PicoZed FMC Carrier Card Revision C Errata

Thank you for your interest in the PicoZed FMC Carrier Card (PZCC-FMC). Although Avnet has made every effort to ensure the highest possible quality, these boards are subject to the limitations described in this errata notification. This document pertains to the PicoZed FMC Carrier Card Revision C.

Figure 2 – Rework which changes Ethernet Port J11 to Address 0x01

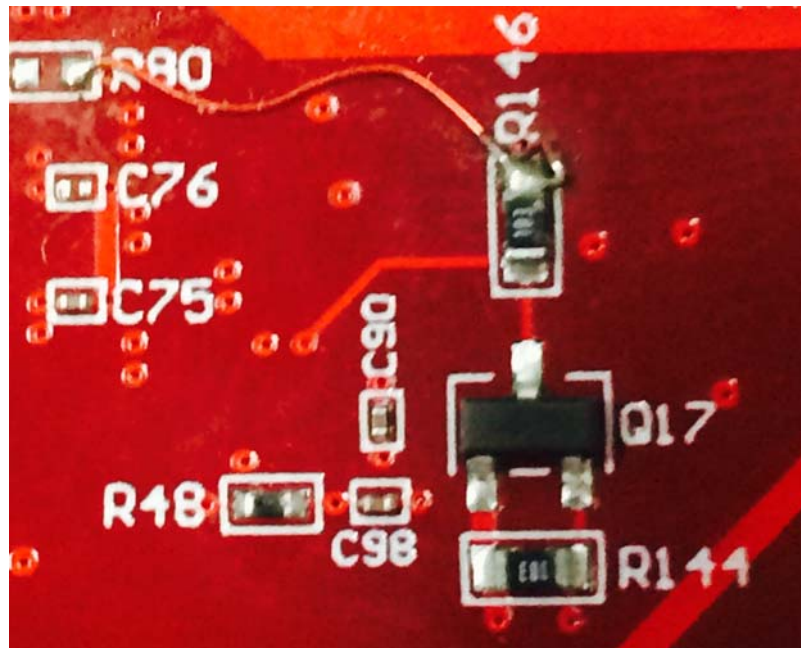
The secondary Marvell 88E1512 PHY on PicoZed FMC Carrier sets the PHY's MDIO address to 0, which is the MDIO broadcast address. Since the Xilinx GMII-to-RGMII shim is also on the MDIO bus, the shim could potentially interfere with communication to the PHY (although the shim does not respond to the broadcast address as of Vivado 2014.4).

Remove R80. Wire the top of R146 to the right pad of R80. This changes the PHYAD[0] from a '0' to a '1'.
